**ZONING AMENDMENT,
PLANNED UNIT DEVELOPMENT &
SUBDIVISION STAFF REPORT**

<u>NAME</u>	La Belle LLC.
<u>SUBDIVISION NAME</u>	La Belle Subdivision, Re-subdivision and Addition to Lot 1
<u>LOCATION</u>	5951 & 5955 Old Shell Road and 14 East Drive (Southwest corner of Old Shell Road and East Drive)
<u>CITY COUNCIL DISTRICT</u>	District 6
<u>PRESENT ZONING</u>	R-1, Single-Family Residential District, and B-2, Neighborhood Business District
<u>PROPOSED ZONING</u>	B-2, Neighborhood Business District
<u>REASON FOR REZONING</u>	Subdivision of land, and resolution of a split-zoning issue created by the proposed Subdivision.
<u>AREA OF PROPERTY</u>	1 Lots / 1.3 ± Acres
<u>CONTEMPLATED USE</u>	<p>Subdivision approval to create 1 lot, Planned Unit Development Approval to amend a previously approved Planned Unit Development to allow multiple buildings on a single building site, and Rezoning from R-1, Single-Family Residential District, and B-2, Neighborhood Business District, to B-2, Neighborhood Business District to eliminate split zoning in a proposed Subdivision and allow construction of a parking lot.</p> <p>It should be noted, however, that any use permitted in the proposed district would

SITE PLAN

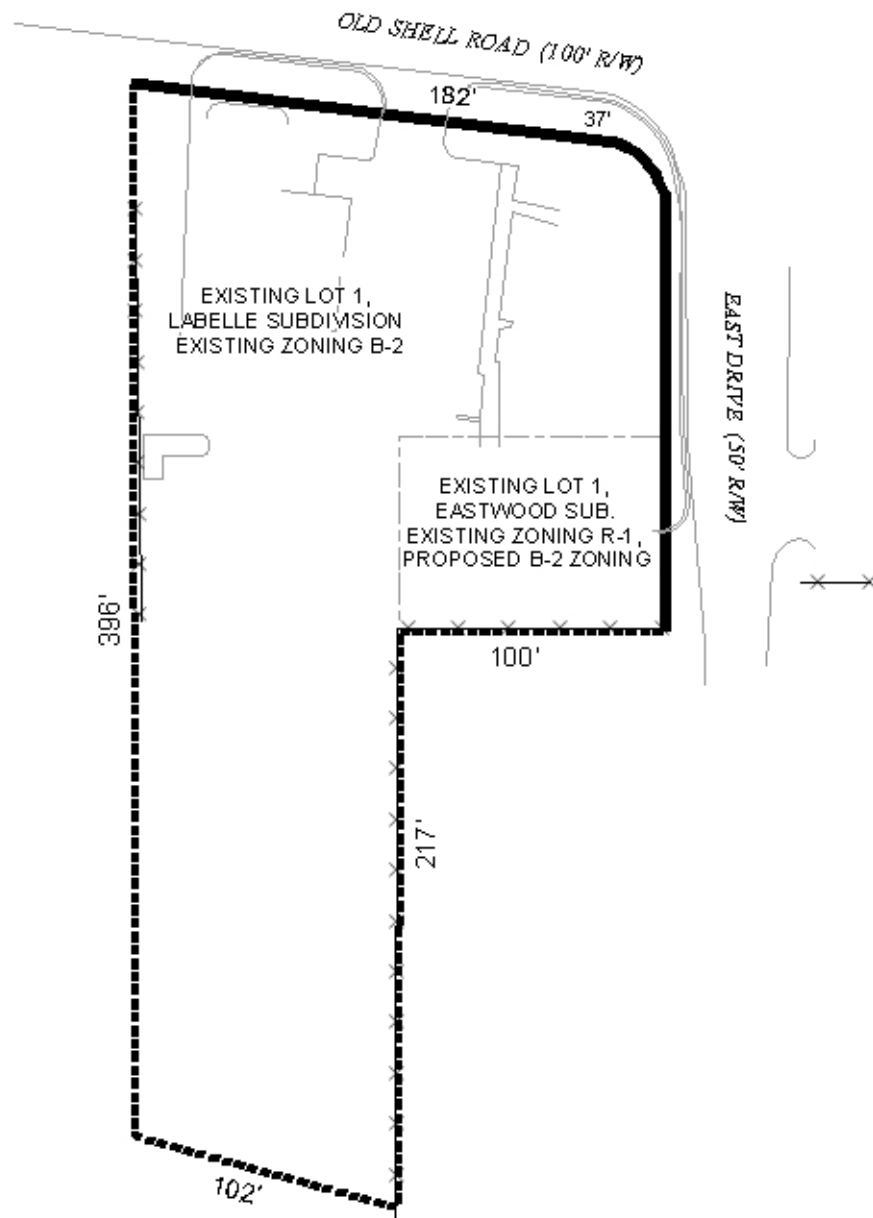
<u>TIME SCHEDULE</u>	No timeframe provided.
<u>ENGINEERING COMMENTS</u>	Must comply with all storm water and flood control ordinances. Detention required for the approximately 1,300 square feet of impervious area added to the site since 1984 in addition to the proposed parking lot as shown on the submitted

site plan. Any work performed in the right of way will require a right of way permit. Drainage from any dumpster pads cannot discharge to storm sewer; must have connection to sanitary sewer.

Driveway number, size, location, and design to be approved by Traffic Engineering and conform to AASHTO standards. The proposed concrete driveway on East Drive is skewed at an approximate 60° angle. Exiting traffic is aimed away from Old Shell Road; vehicles not likely to exit at this angle will block southbound vehicles from entering the driveway. Driveway should be designed with minimum skew; 90° angle is desired. A 20' radius is typical for passenger cars and a 30' radius is desirable for large trucks. The distance between the edge of pavement and right-of-way line (approximately 10') and the proximity of live oak trees may prohibit the proper radius; if so largest possible radii are desired.

The applicant proposes to develop the residentially-zoned portion of the site to include paved parking, trees, landscaping and an additional entrance for the development from East Drive. Currently, the site does not have access to East Drive, thus all traffic associated with the restaurants enters and exits the site via curb-cuts onto Old Shell Road. Access to East Drive will afford access to and from Old Shell Road via an intersection with a traffic signal. As designed, however, the curb-cut to East Drive will be angled, creating an awkward turning angle for

vehicles entering the site from southbound East Drive. A large live oak tree in the proximity of the proposed curb-cut may be the reason for the proposed design, however, Traffic Engineering has requested as close to a 90-degree driveway as possible.

Staff agrees that additional parking closer to the existing restaurants will be more convenient for patrons, but disagrees that the additional parking will reduce the impact to adjacent residences. The proposed parking will instead increase the commercially proximity burden on an existing residence, by increasing the proximity of vehicles to the site, increasing the light penetration of vehicle headlights, through required lighting of the parking lot site, and by creating vehicular traffic along the North property of the residence. Furthermore, the access proposed to East Drive will increase traffic on East Drive, including delivery trucks, garbage trucks and patrons.
